> Our ref: 15600/D3 14<sup>th</sup> May 2019

## Re: 1 Ferncroft Avenue - Side Boundary Wall

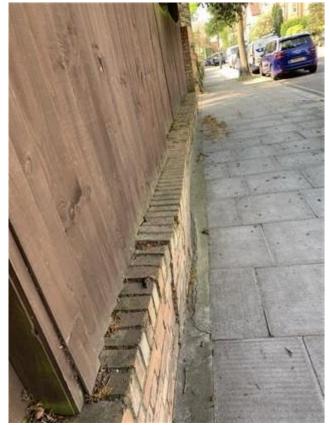
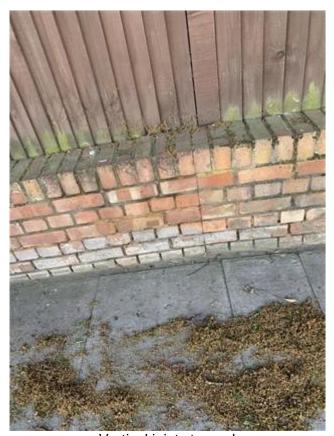
- 2.0 A row of trees run along the boundary brick wall. Along with a large tree that may have a TPO on it. This tree is quite close to the wall.
  - 2.1 The wall was noted to be leaning outward. The deflection increases as we move close to the large tree noted above. This together with vertical shear cracks. We believe that it is not long before the wall could reach critical stage leading to collapse.

Vertical joint stagged

Note - movement

Note – vertical & horiztonal movement

Diagonal cracks (1)

Diagonal cracks (2)

- 3.0 We suggest the following
  - 3.1 Remove the wall and have it rebuilt in line with its surrounding.
    - Remove row of trees.
    - The large tree we understand needs to be kept.

- 3.2 Regards wall's foundations.
  - Traditional strip footing after giving time for soil to come to its natural state. This after the removal of trees.
  - Around the large tree to protect its tree roots. Use steel screw piles with concrete reinforced beam above, below the brick wall on this concrete. Vertical expansion joint will be needed to allow for differential movement.
- 3.3 Wall should be enhanced by brick piers.
